Date: October 11, 2006

GTHB & GTHC Return Air Dimension Error IOM Literature

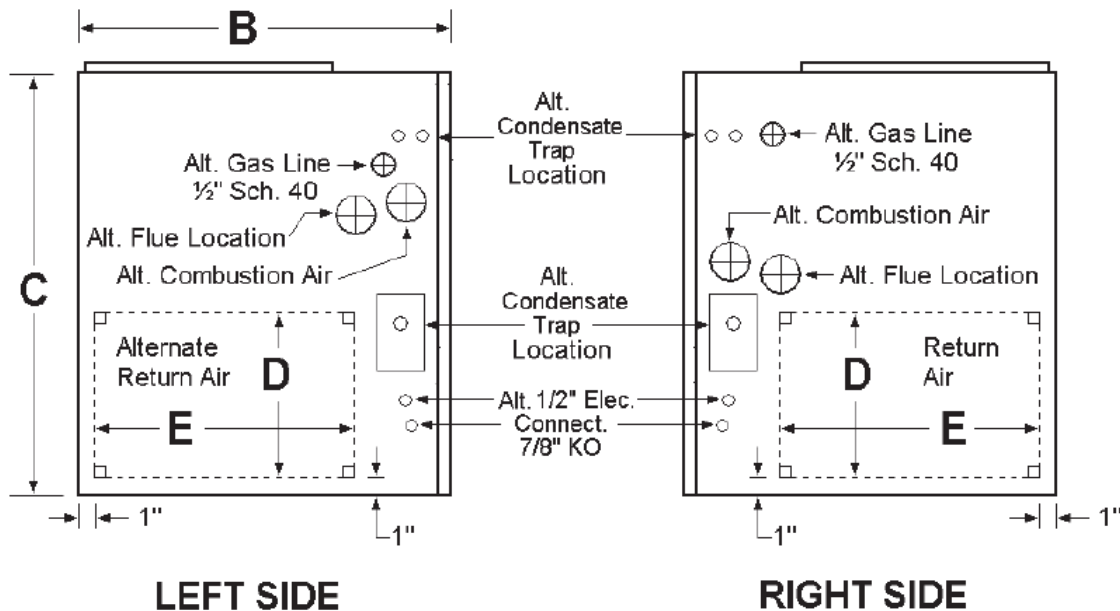
An error in the Installation Manual and Operating Instructions for the GTHB and GTHC - Natural Gas and Propane Gas High Efficiency (Condensing) Warm Air Furnaces has been identified for the return air opening. The literature incorrectly indicates the Return Air dimensions. The correct Return Air dimensions (D x E) are 14" x 22".
